APPENDIX C

Subject: Triangle - External works - Main entrance canopy

APPENDIX D

BASIC. APPROX DIMENSIONS.

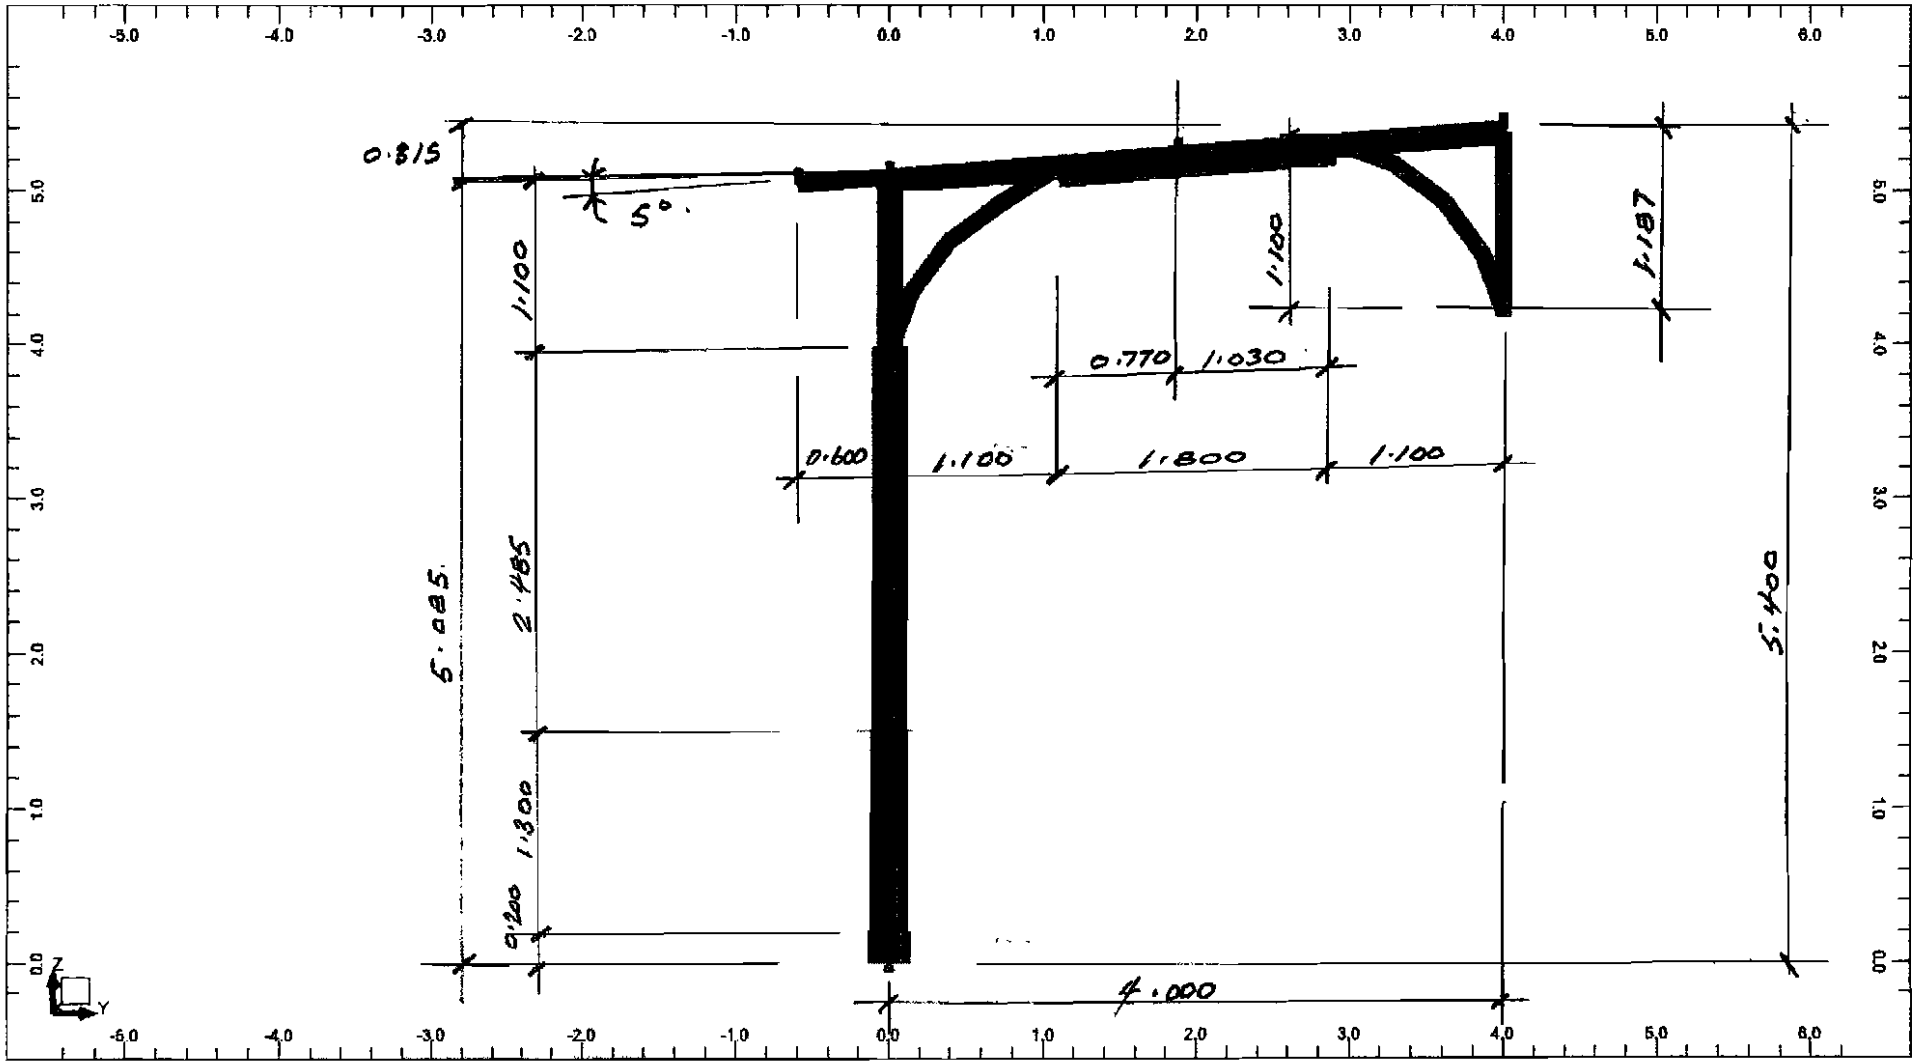
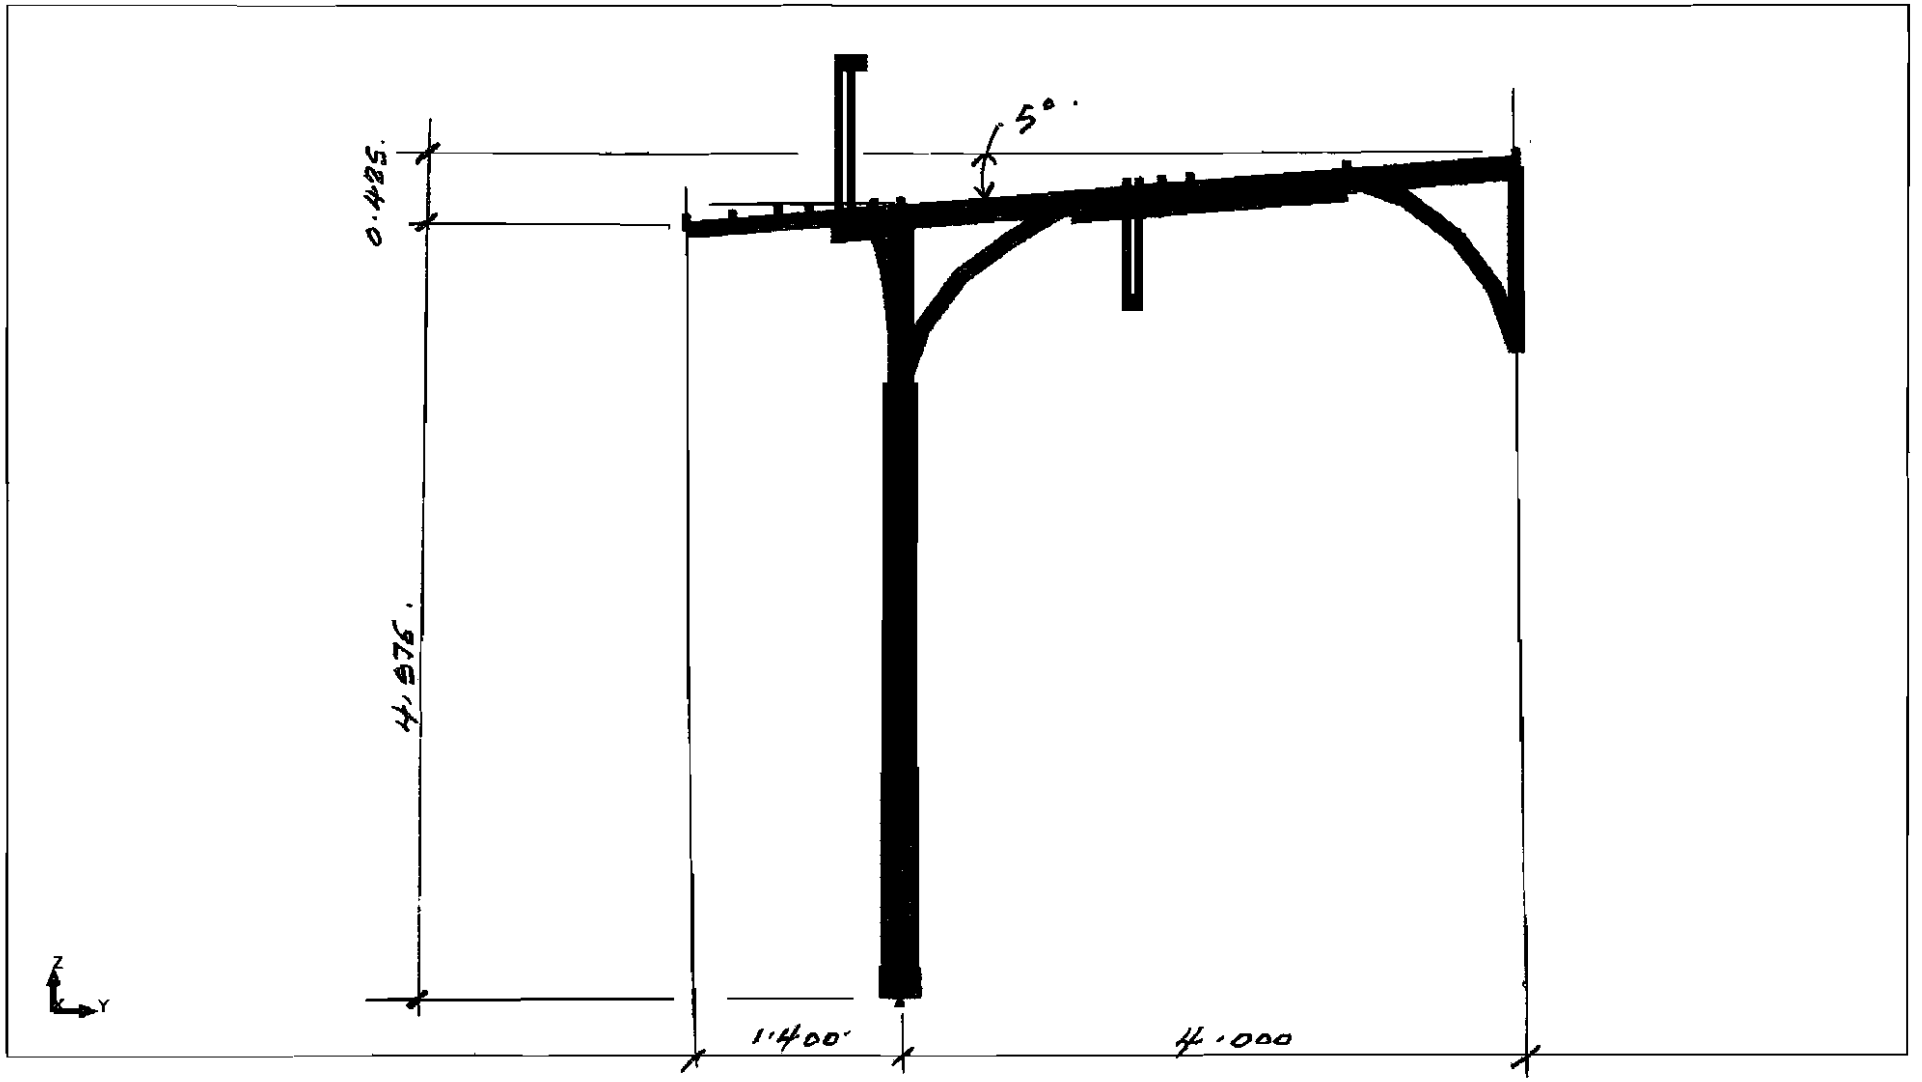
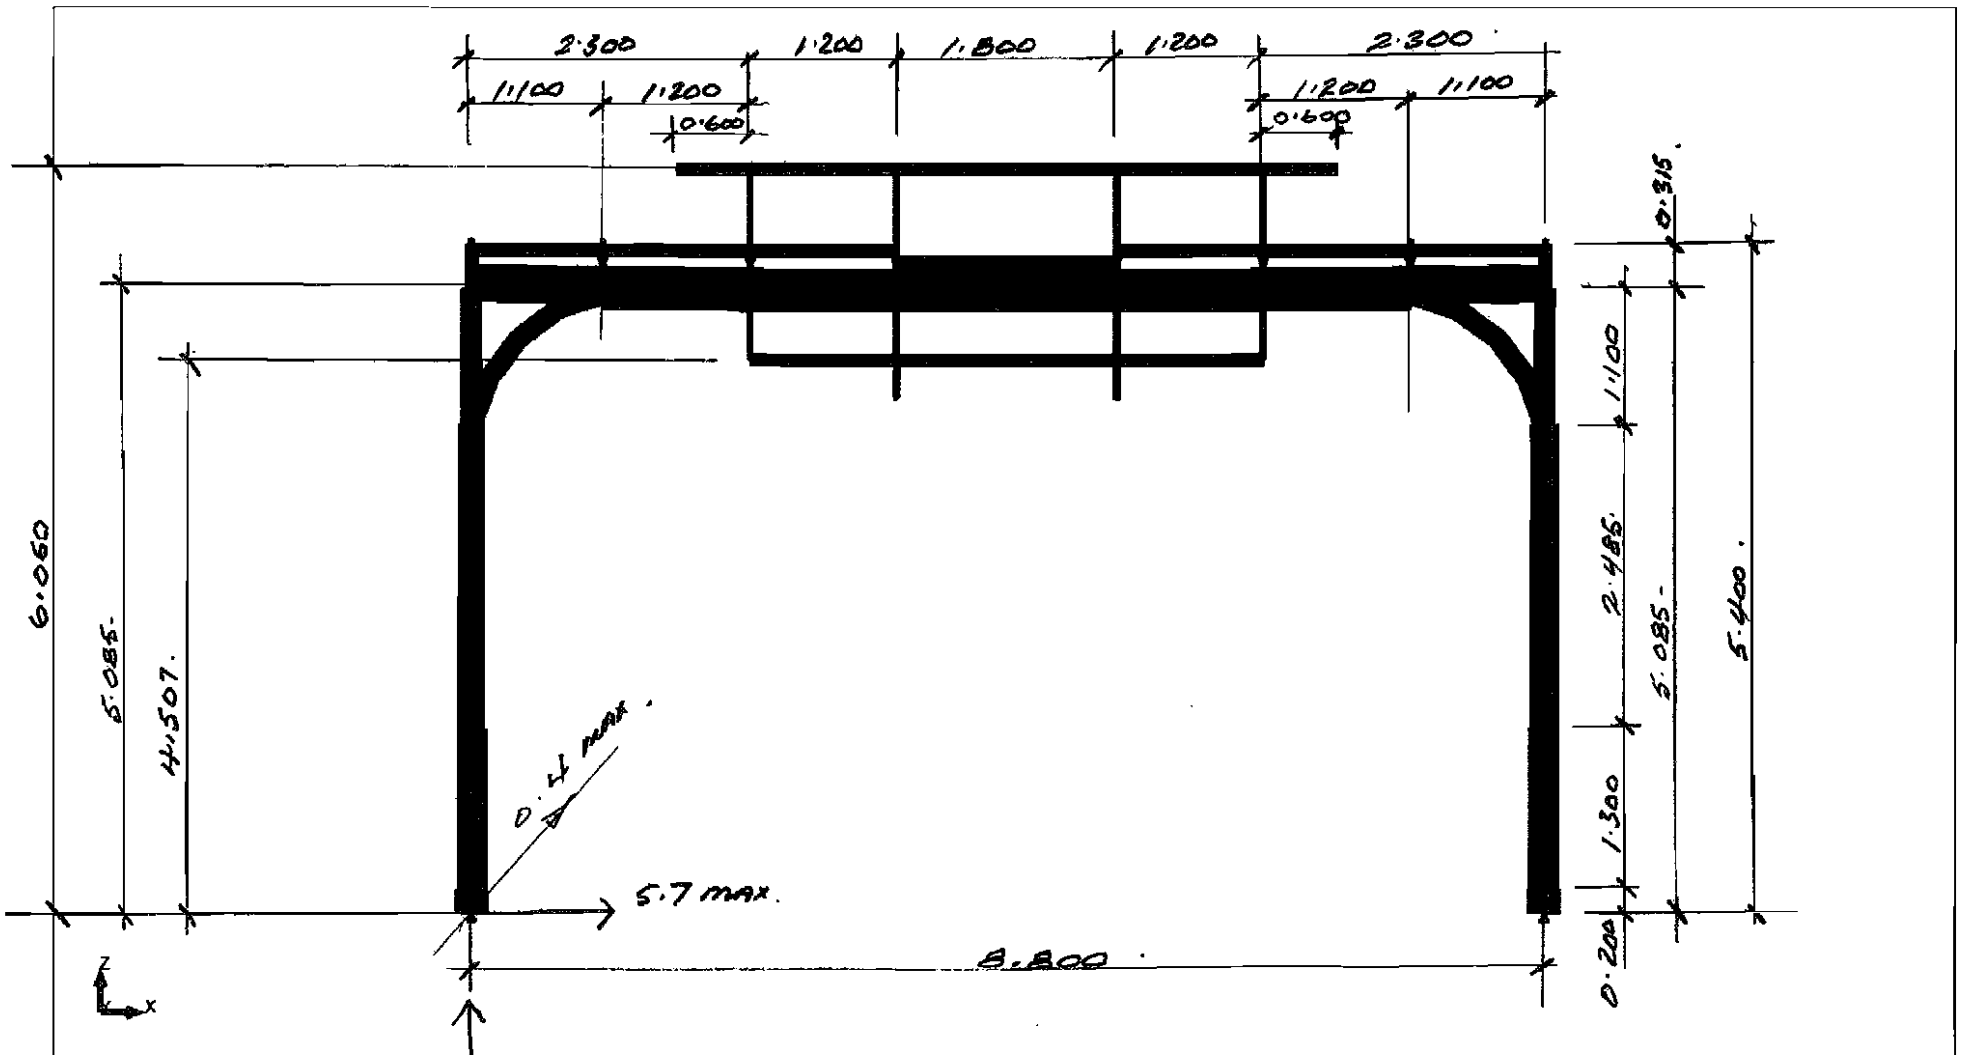
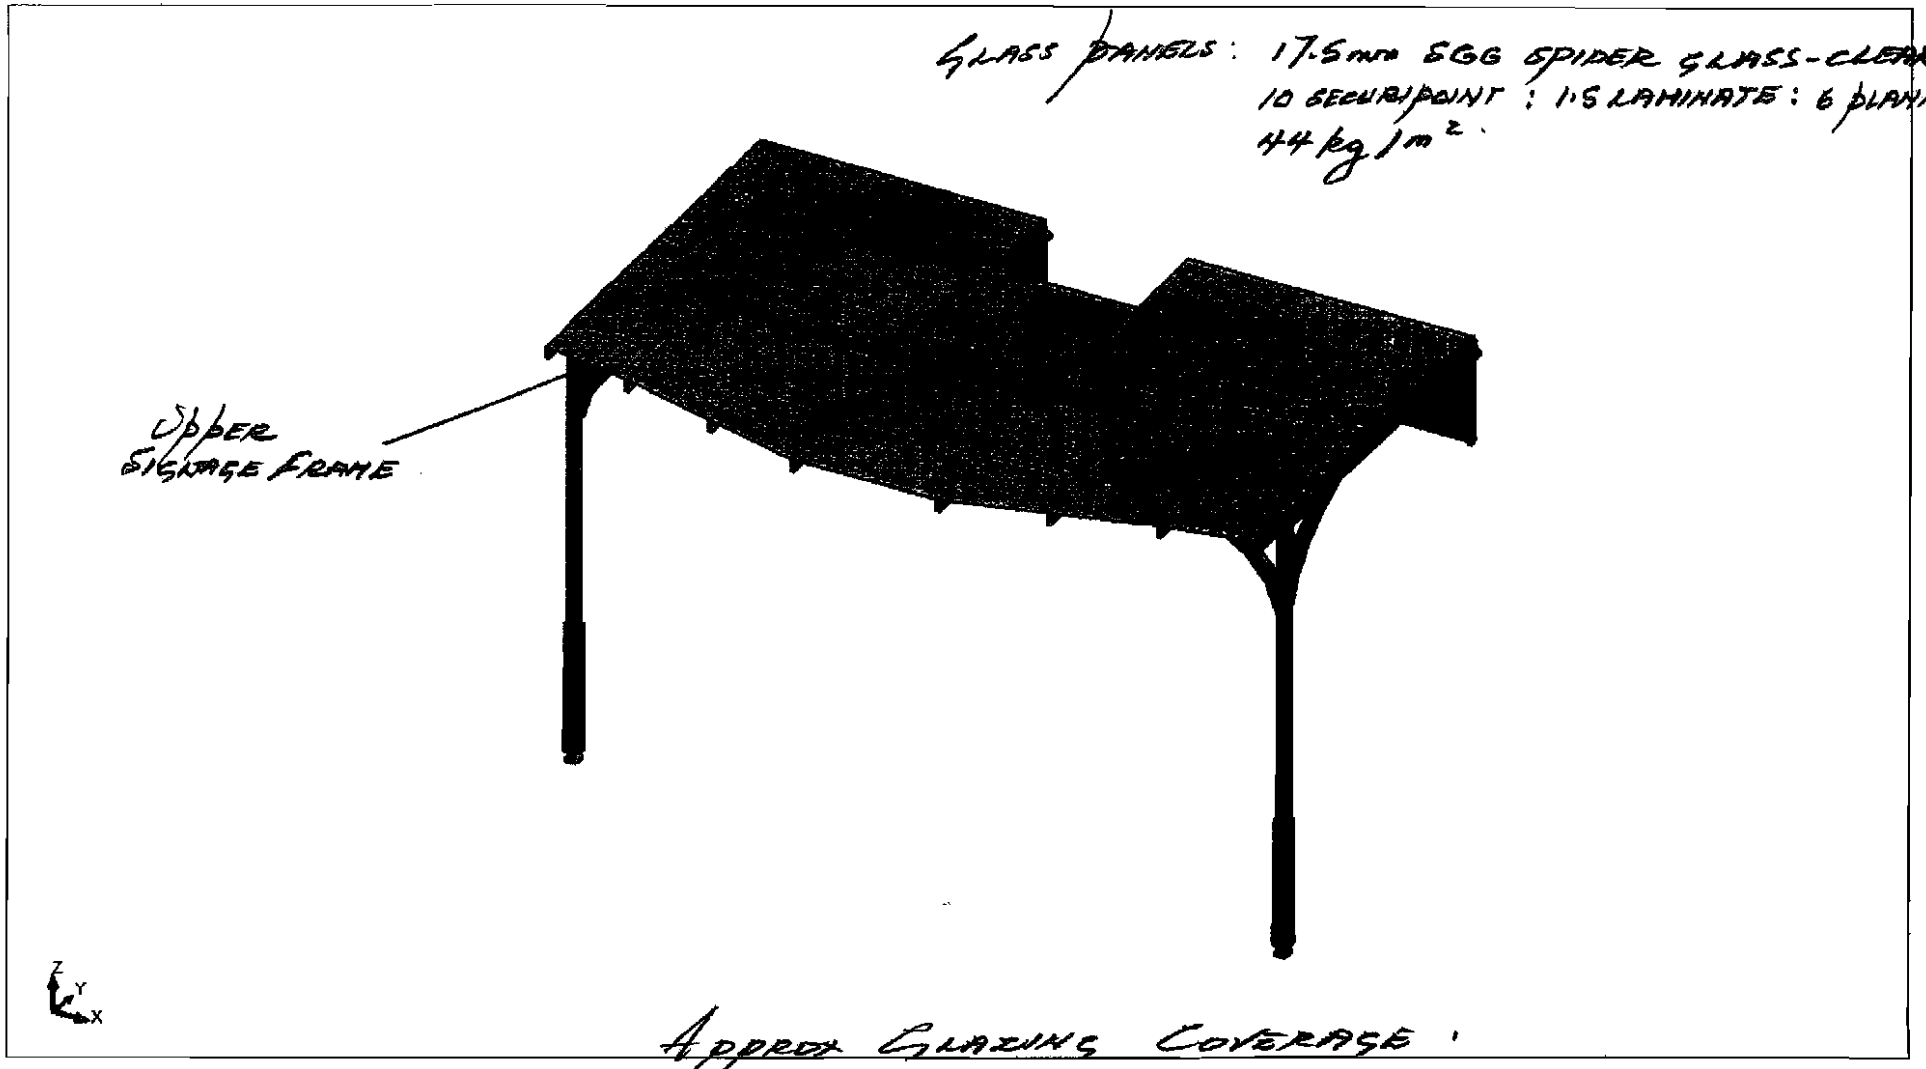
The canopy design, as proposed in the email from Manchester City Council, assumes full cantilever support from the face of the building. The plan area is approximately 9m wide by 4m deep at 5.3m above pavement level. The canopy is to be of glass panelling with a steel support frame. The thickness of glass required to counteract wind uplift is 17.5mm laminated. The glass could be thinner, however the 8 upper tie rods would need to be significantly increased in size as they would need to be designed as struts.

It is our calculated view that due to the weight of glass, the snow and wind loading and the position at which the tie rods can be connected back to the building, the forces in the tie rods are unworkable. We are concerned that the structure is overly heavy and excessive and that there are problems providing the necessary support back to the building.

In our view, the raking tie bar supports, where they attach to the canopy from the main elevation of the building, are too close to the building even with 8 tie rods. The central connection of the tie bar to the stone pier is also looking quite big at 350mm in length and width (0.1225sq.m).

It is strongly recommended that alternative means of support be investigated to eliminate the need for the raking tie rods which induce the cantilever moment and torsion in the first floor level beams. This could be achieved by providing a pair of front posts thus eliminating the cantilever requirements at the building face. This is being investigated further.
